Recommended Design

GREENWOOD PLACE
14307 Greenwood Avenue North

Response to Early Design Guidance Review Comments Site Planning

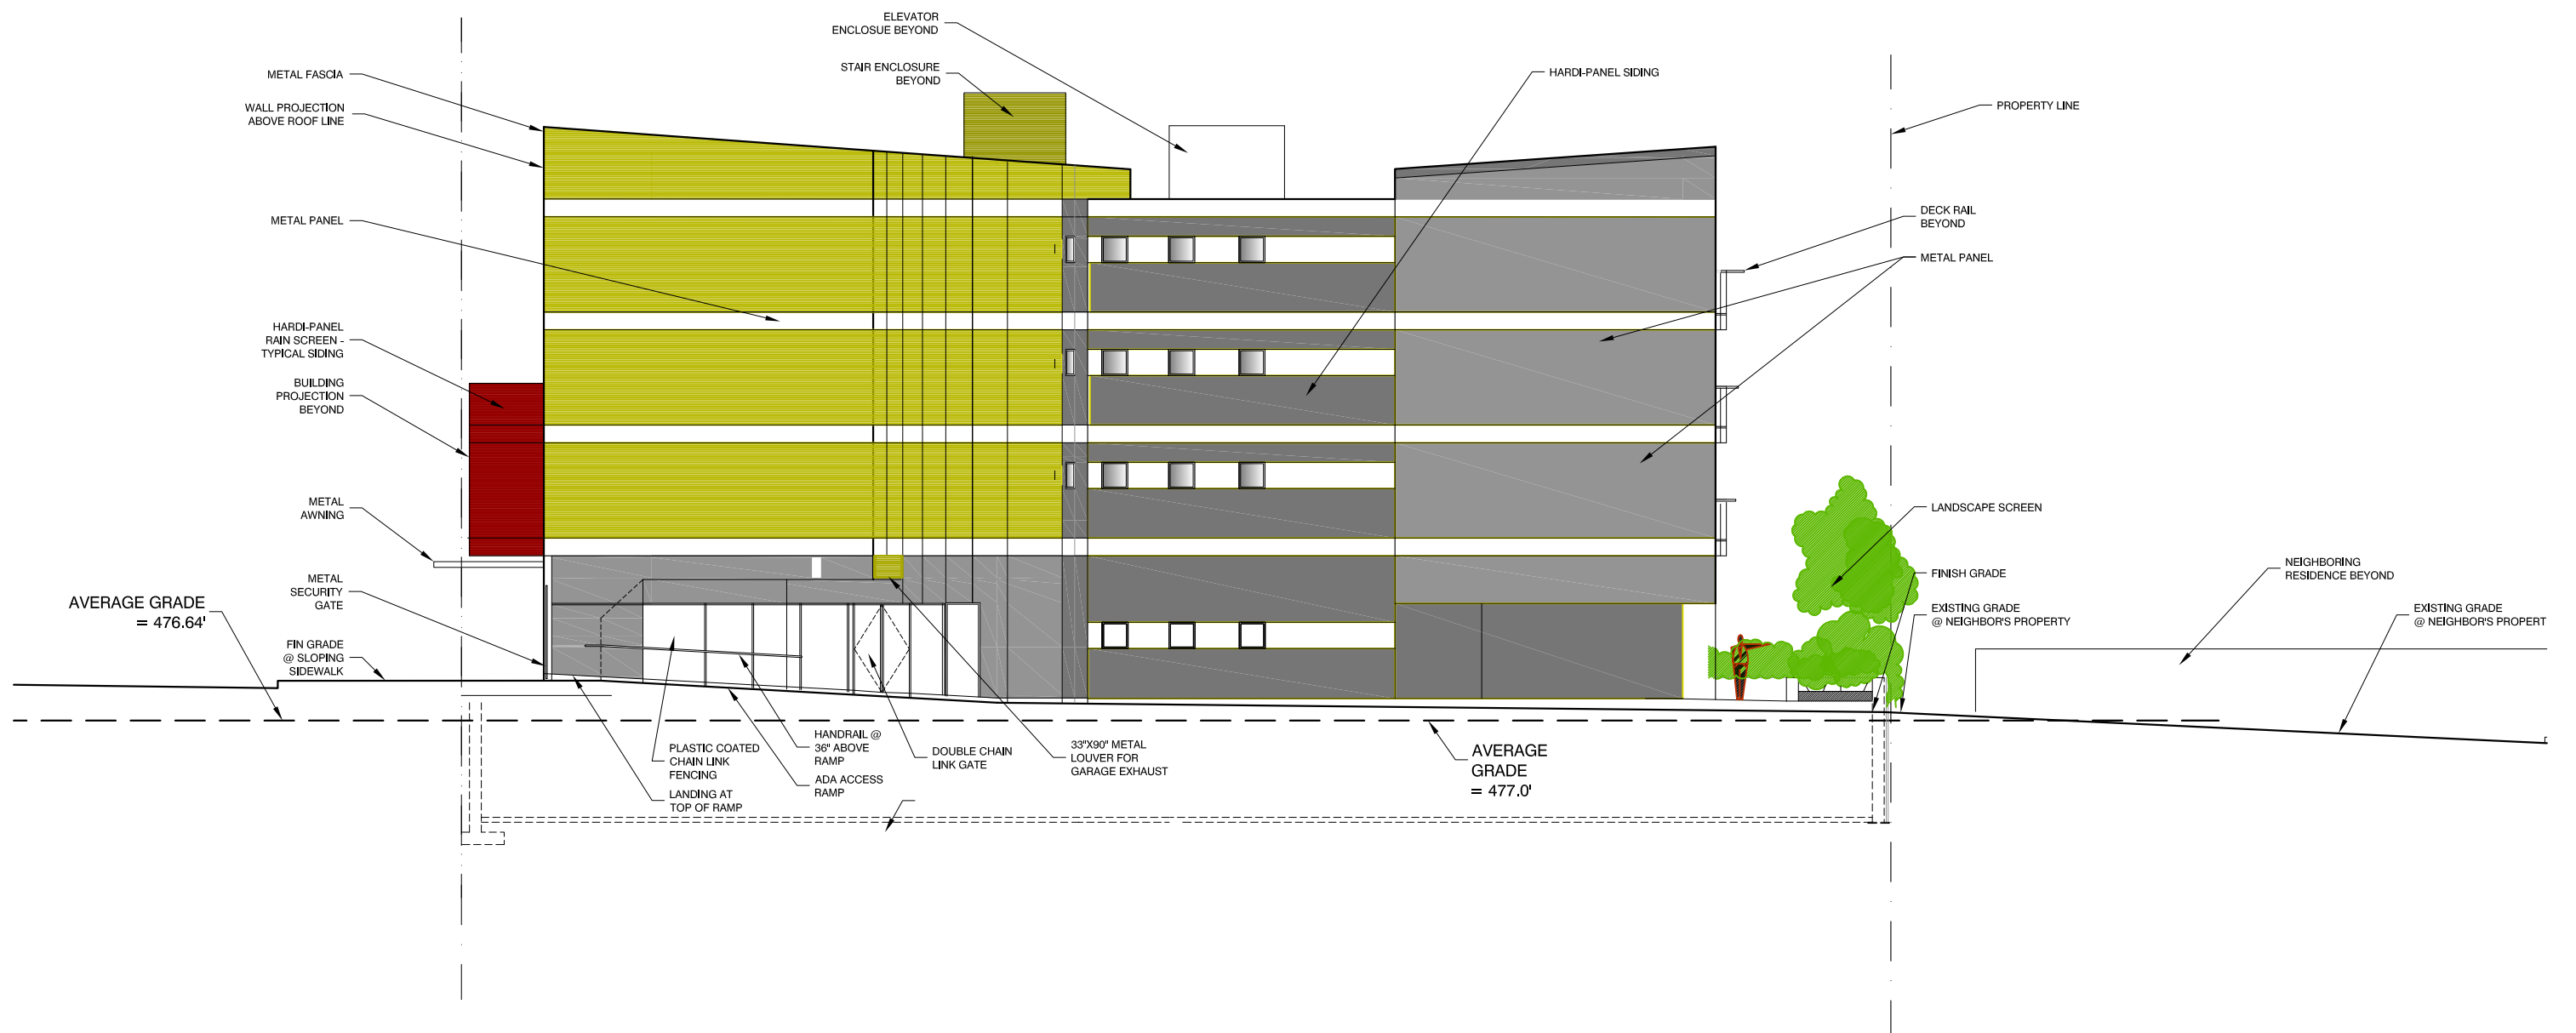
The Board acknowledged the reduction in building scale at the property's southwest corner in response to the transition to a lower scale zone. The treatment of the proposed west facade will be scrutinized at the Recommendation meeting. See guidance A-5. The decks, fenestration and choice of materials should possess a residential scale compatible with the building's surroundings.

The recommended design proposes :

- stepping down of the southwest corner massing for roof terrace
- the west facade has been substantially modulated with decks, built-in guardrail screens and view privacy "fin" walls
- the landscaping within the building setback on the west side has been expanded and devised to provide a scale break up for the new building
- the existing nine foot tall rockery will be replaced with climbing vines over the exposed basement wall that will form a greenwall edge to the adjacent property
- fenestration on the west facade will be smaller or deeply setback at deck
- windows will be more residential in character and scale than elsewhere in the building.
